**EASTON DEPARTMENT OF PUBLIC WORKS  
EASTON, MASSACHUSETTS**

**RED MILL ROAD WATER TREATMENT PLANT  
CONTRACT DPW-2022-05**

**ADDENDUM NO. 3**

**November 5, 2021**

ELECTRICAL  
BLOCK DIAGRAMS I

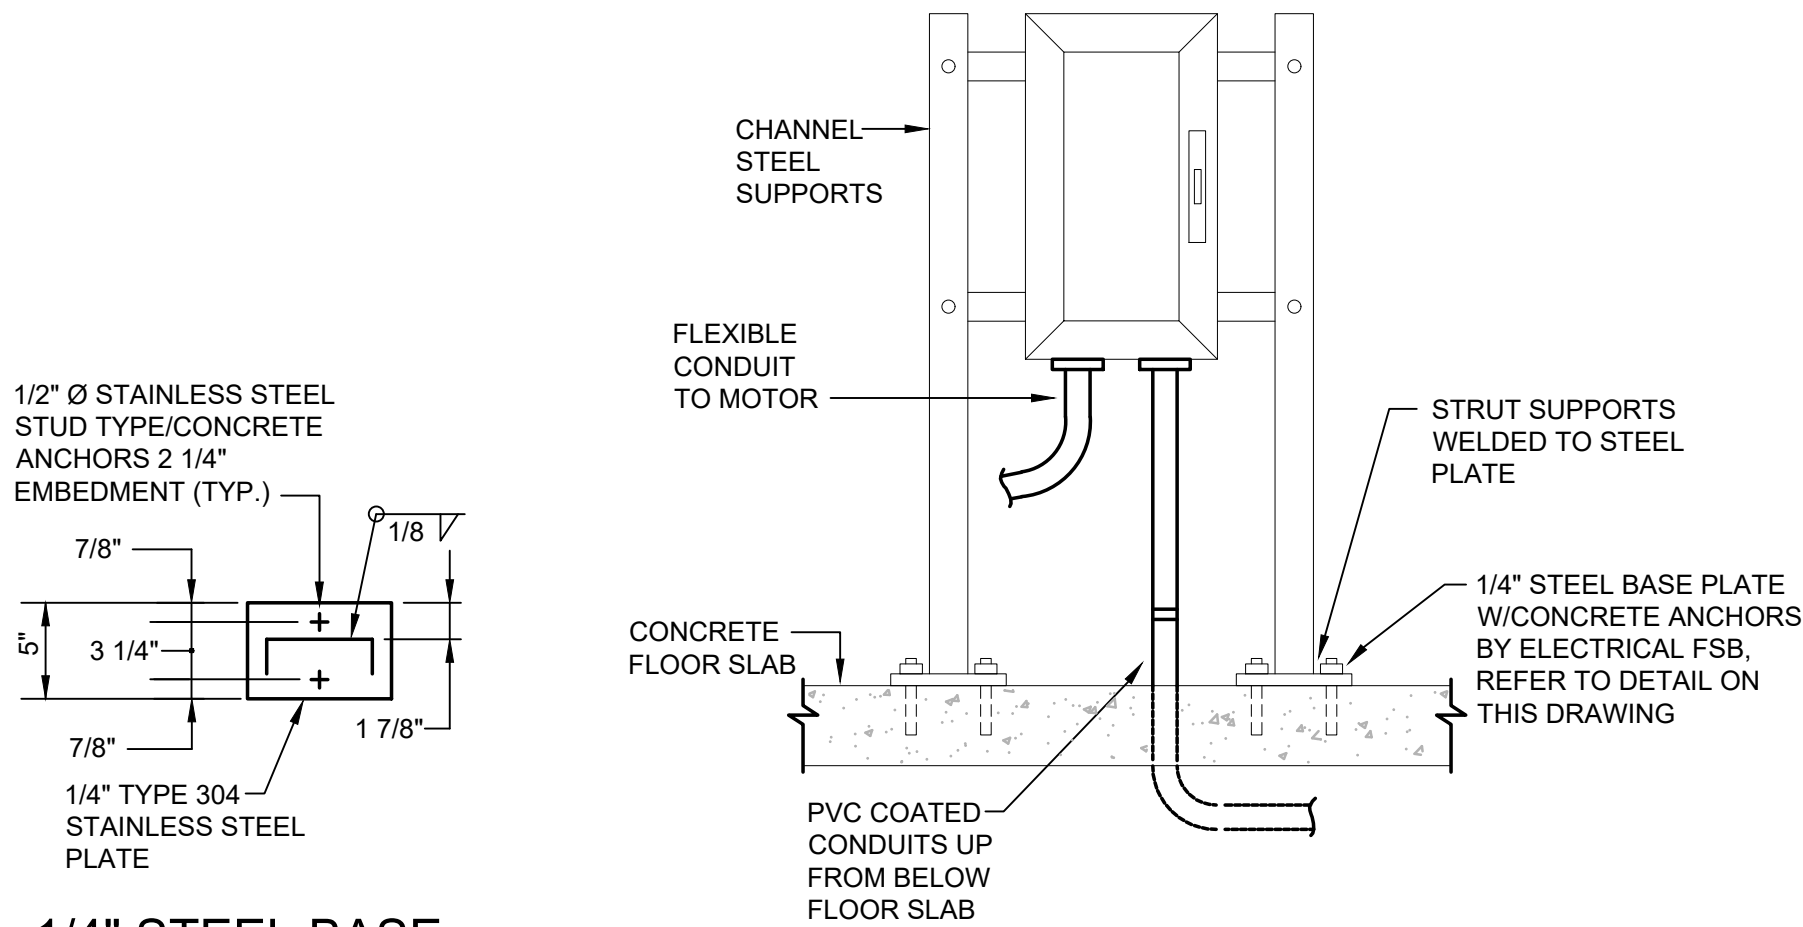
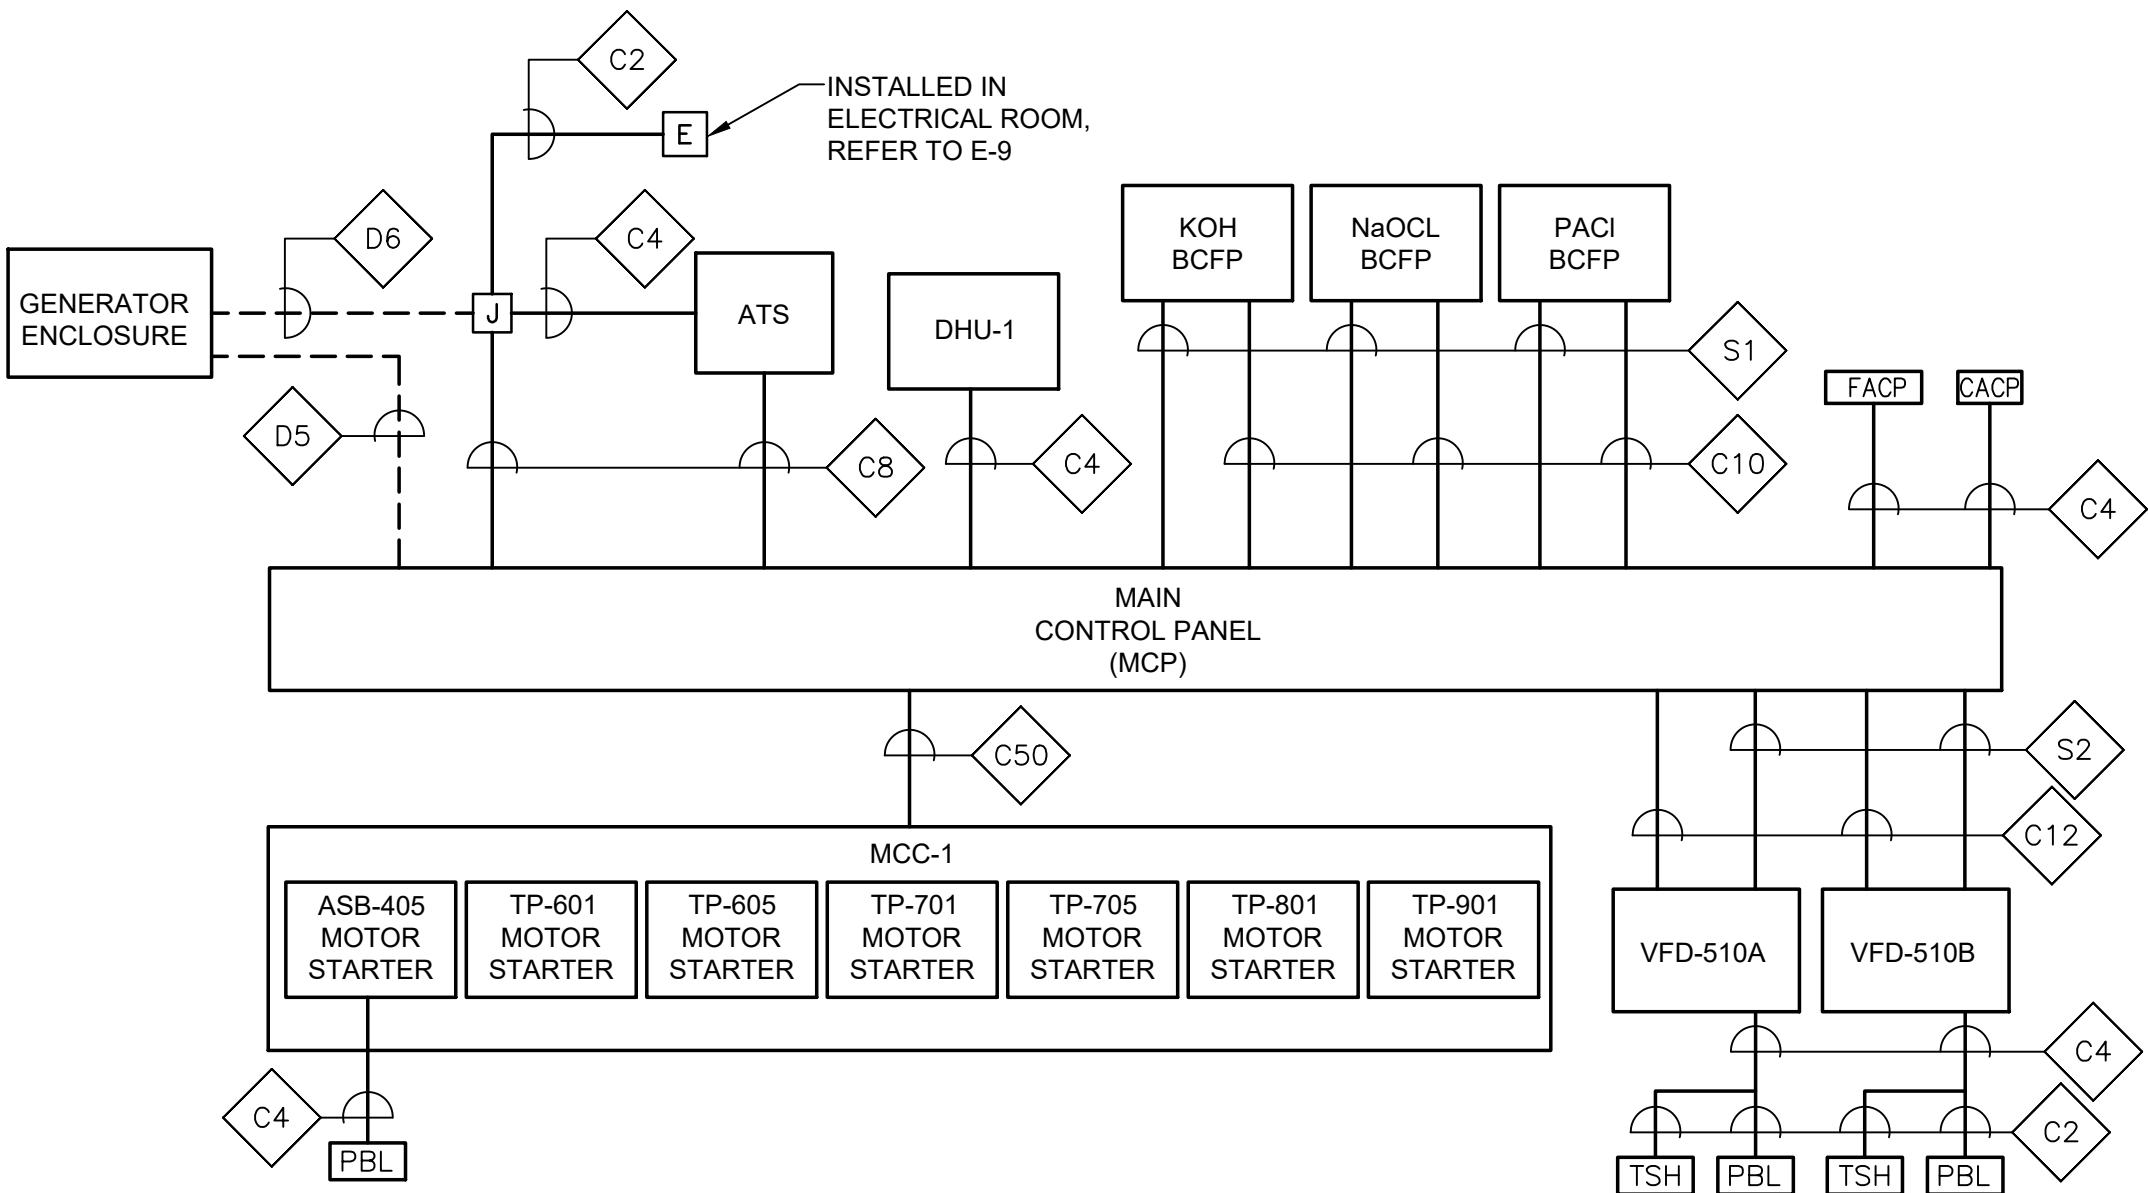
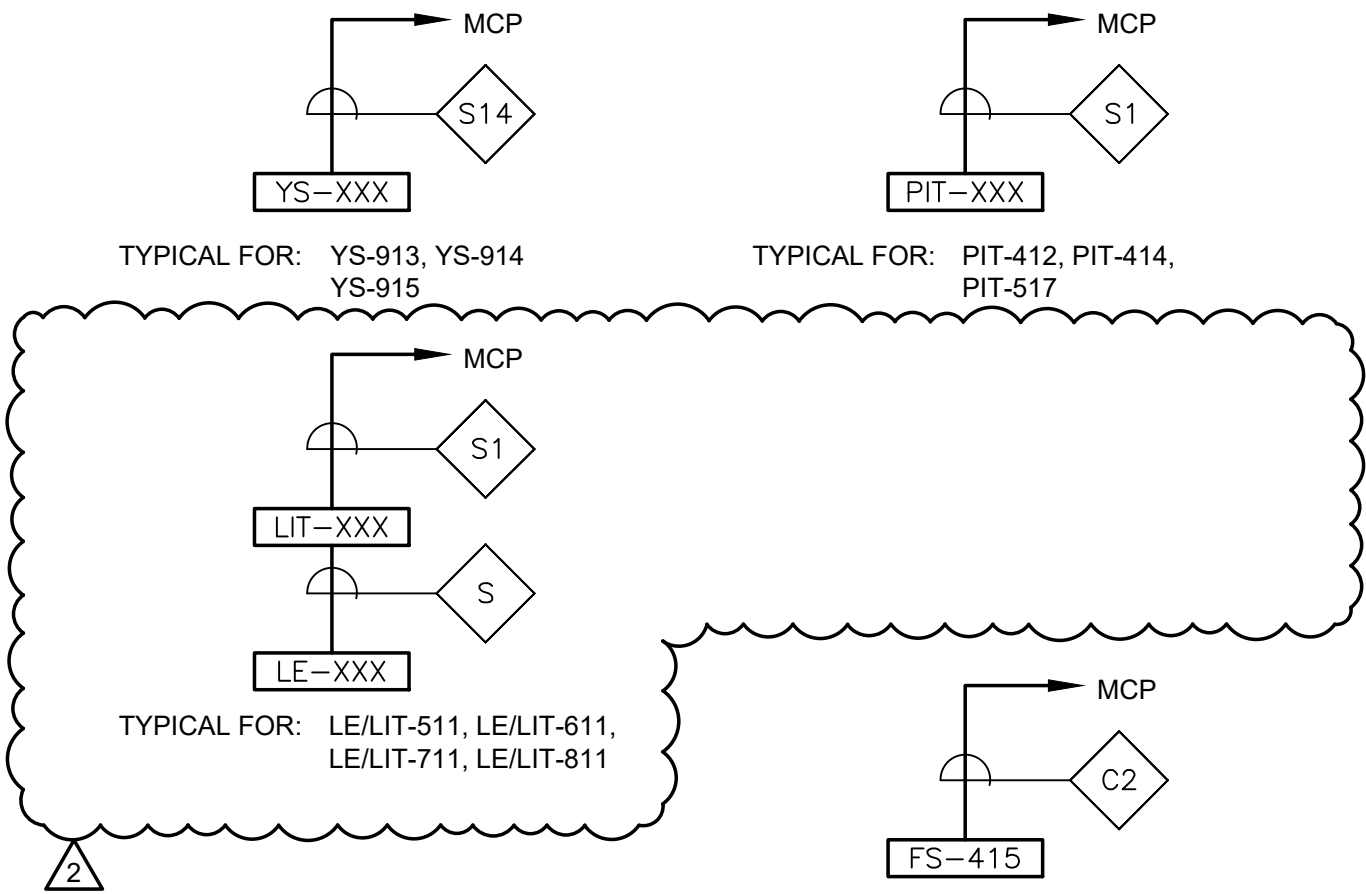
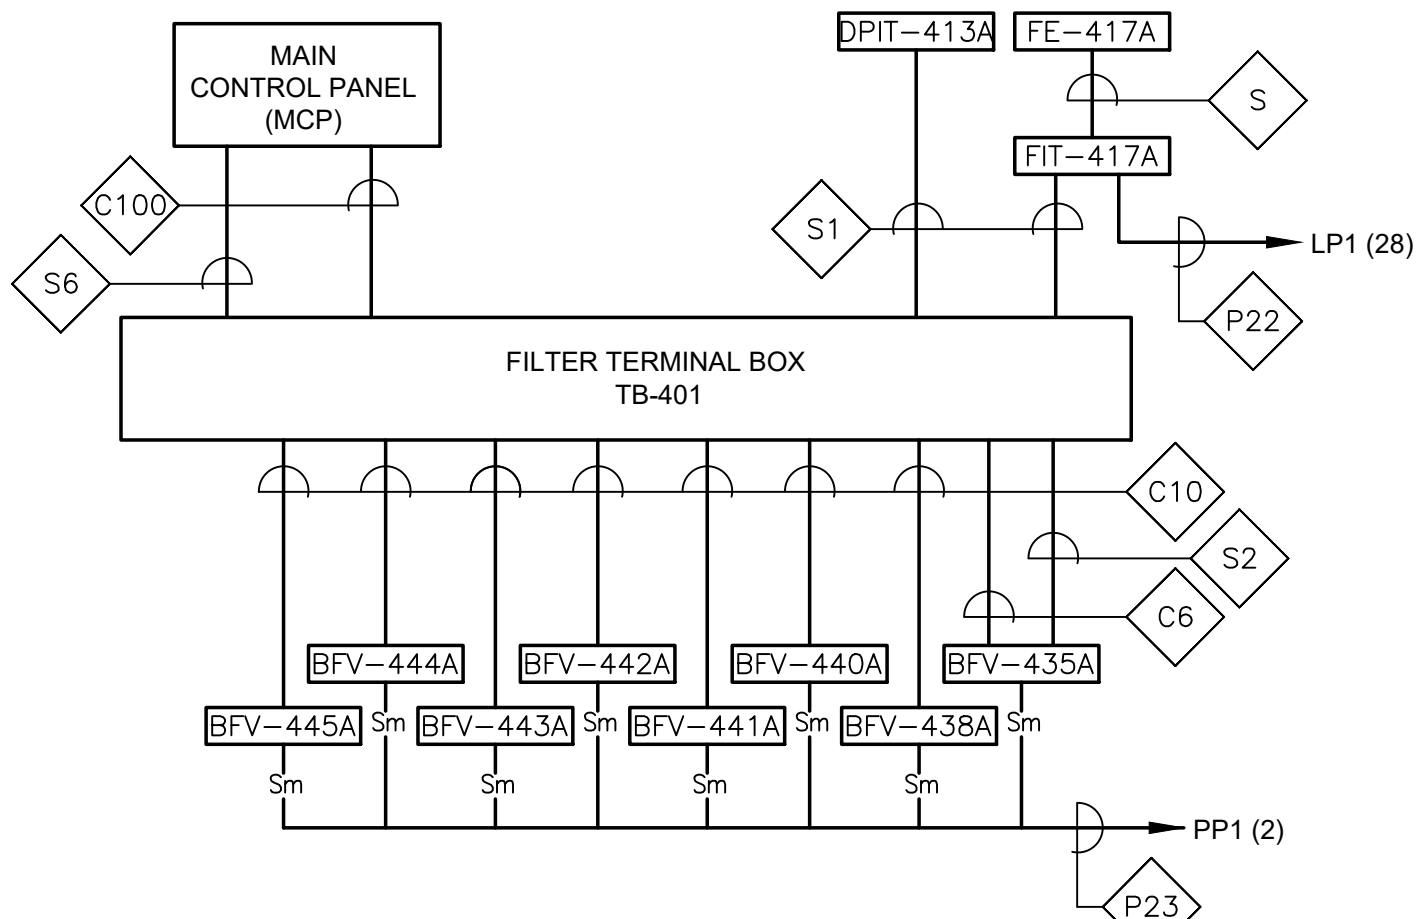
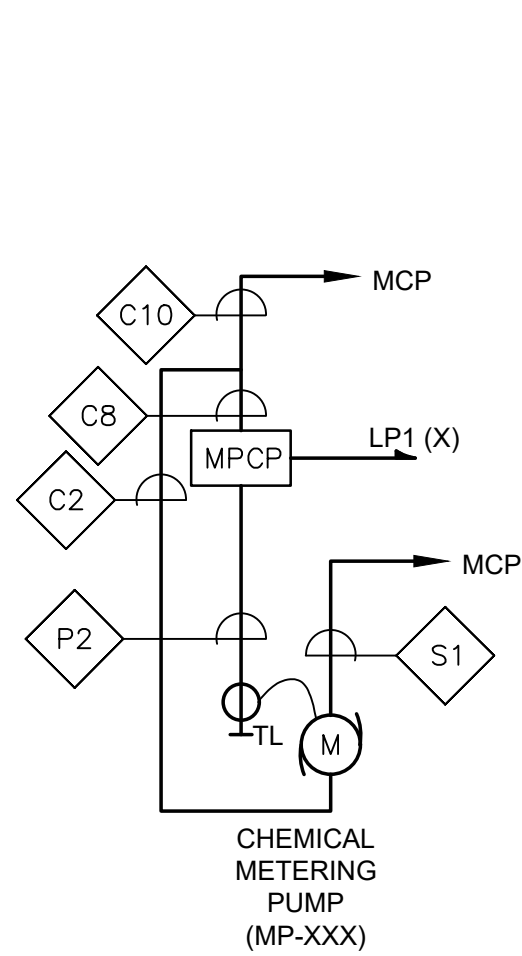
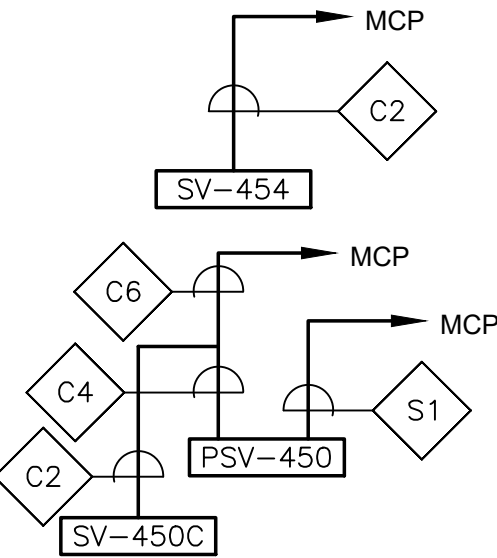
*Answer 10: Refer to Drawings C-9 (Inset Plan C), C-12, and E-17. The conduit is for the septic tank high level float switch (LSH-981).*

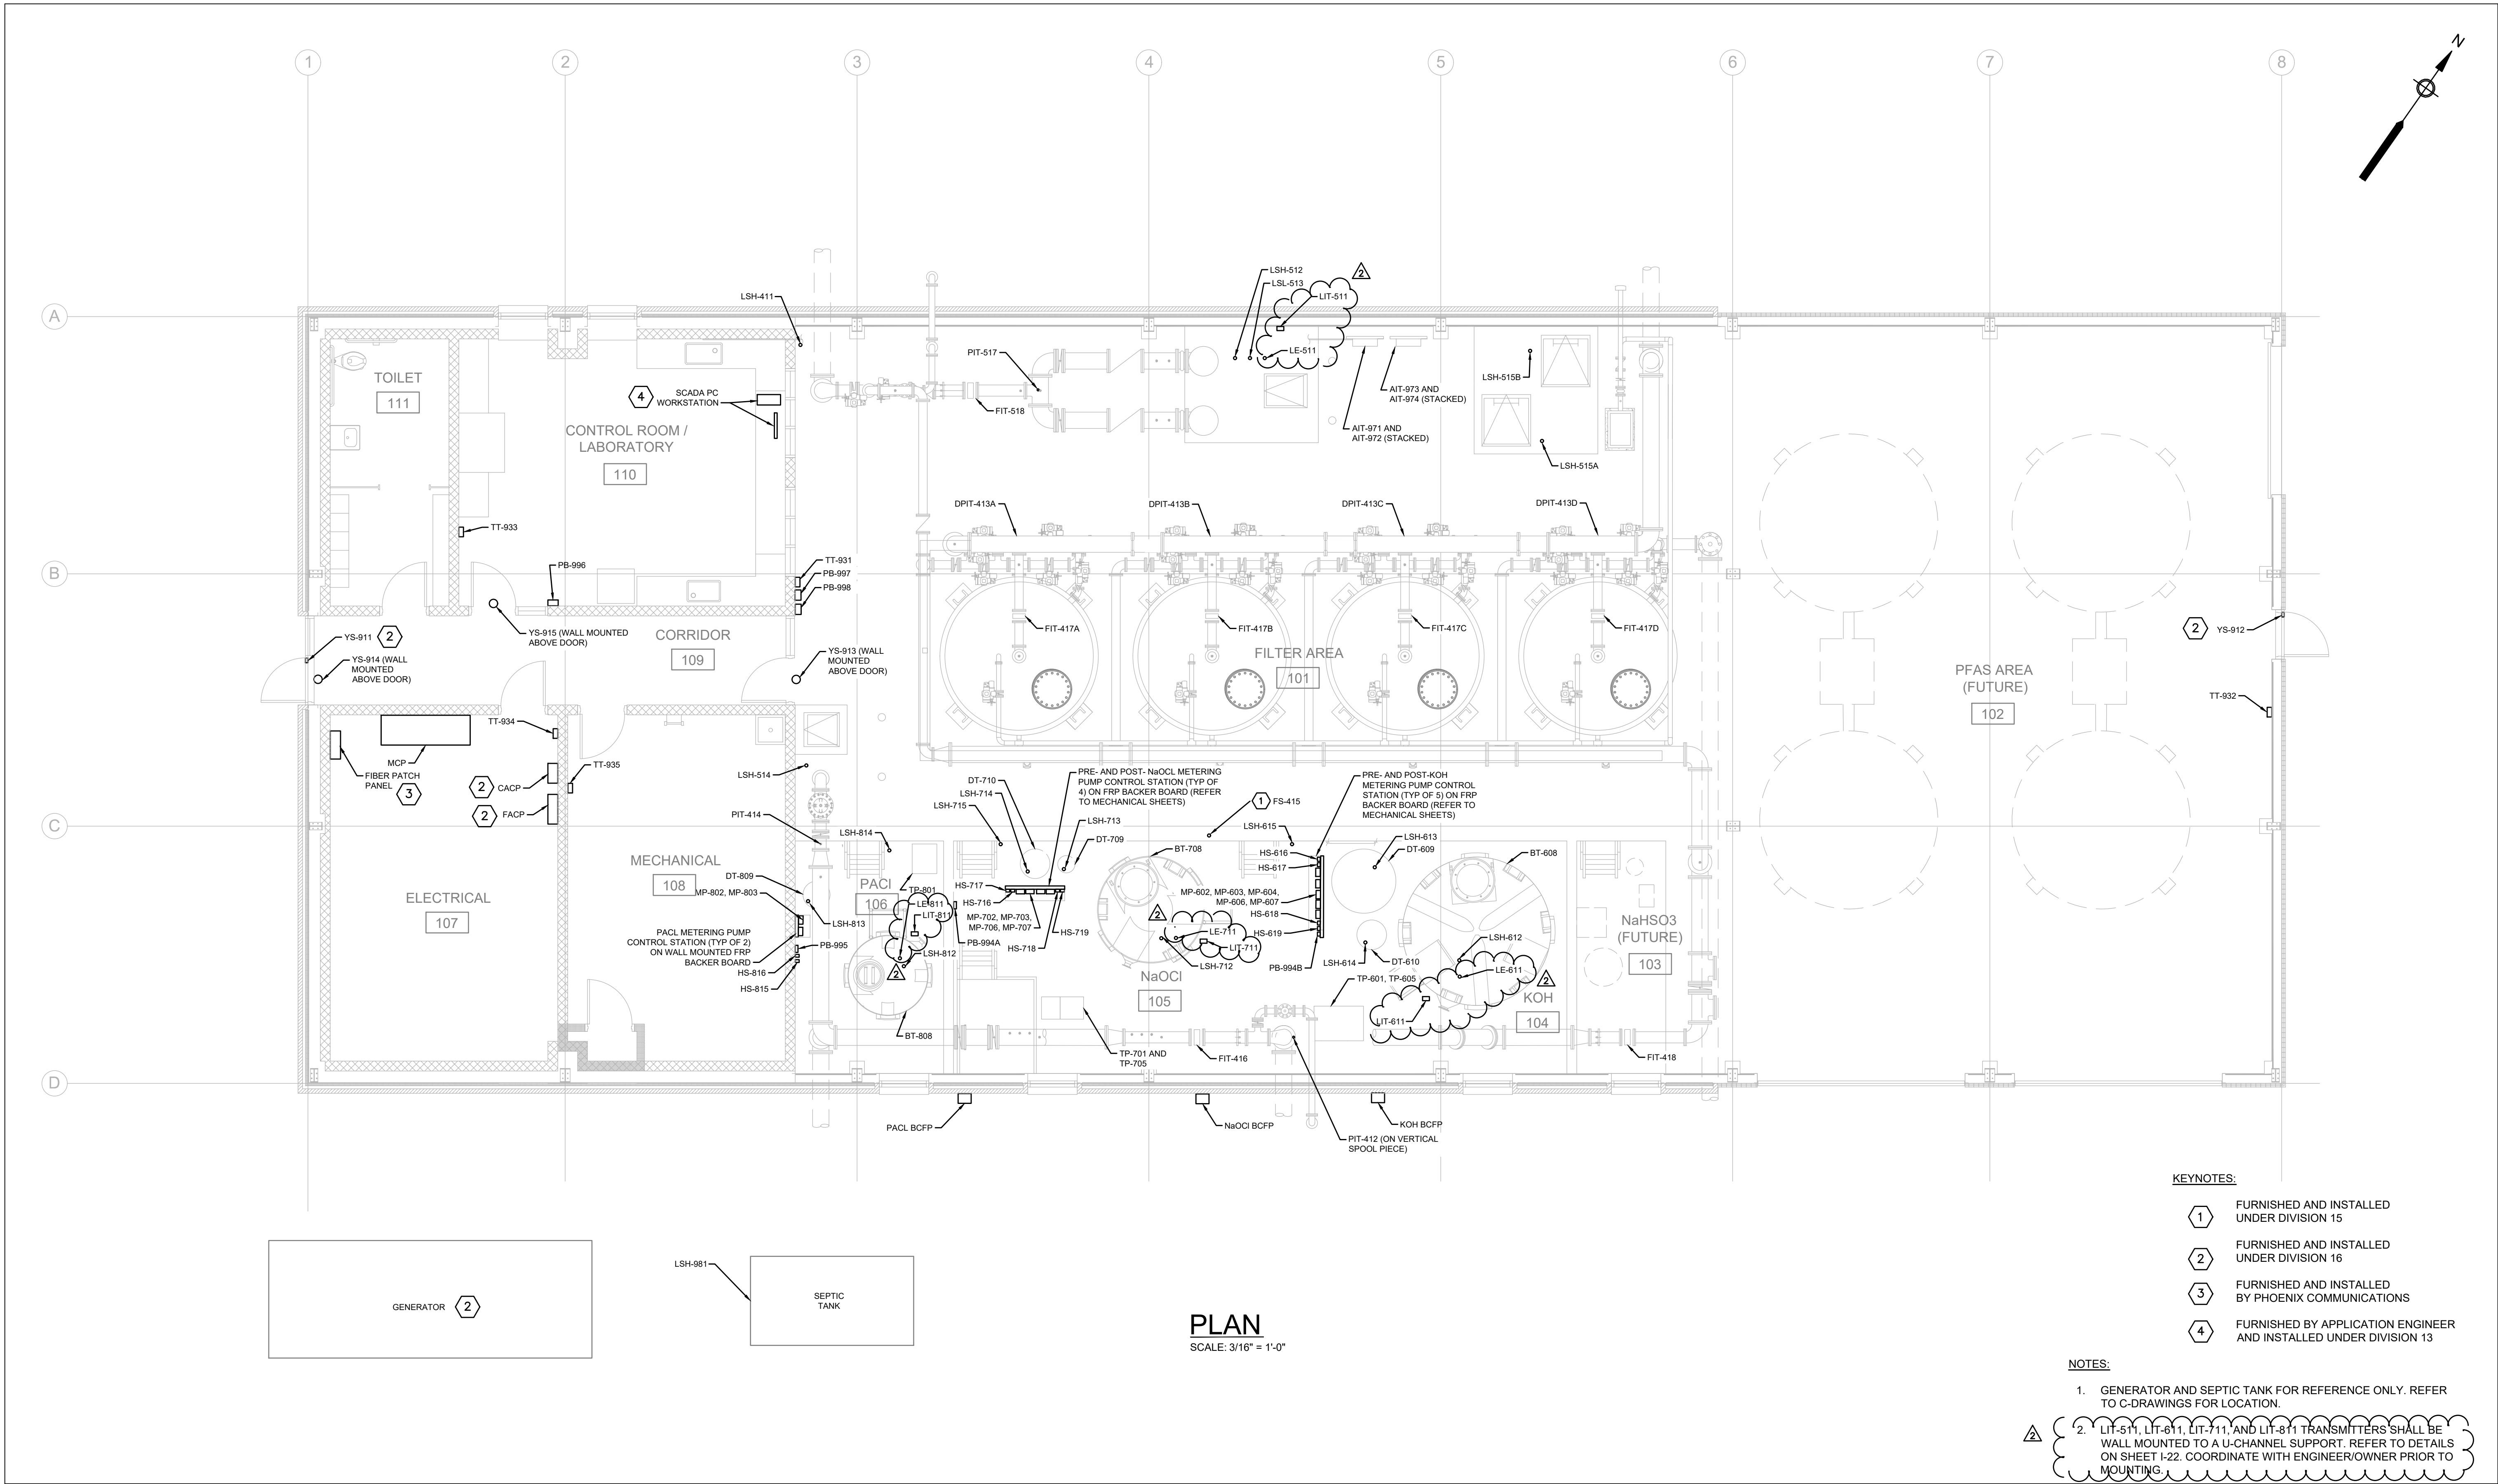
- In the "ULTRASONIC LEVEL SCHEDULE" table, change the "VOLTAGE" column contents for LIT-511, LIT-611, LIT-711, and LIT-811 from "LOOP POWERED" to "120V".

- NOTES:
- 1. GENERATOR AND SEPTIC TANK FOR REFERENCE ONLY. REFER TO C-DRAWINGS FOR LOCATION.
  - 2. LIT-511, LIT-611, LIT-711, AND LIT-811 TRANSMITTERS SHALL BE WALL MOUNTED TO A U-CHANNEL SUPPORT. REFER TO DETAILS ON SHEET I-22. COORDINATE WITH ENGINEER/OWNER PRIOR TO MOUNTING.
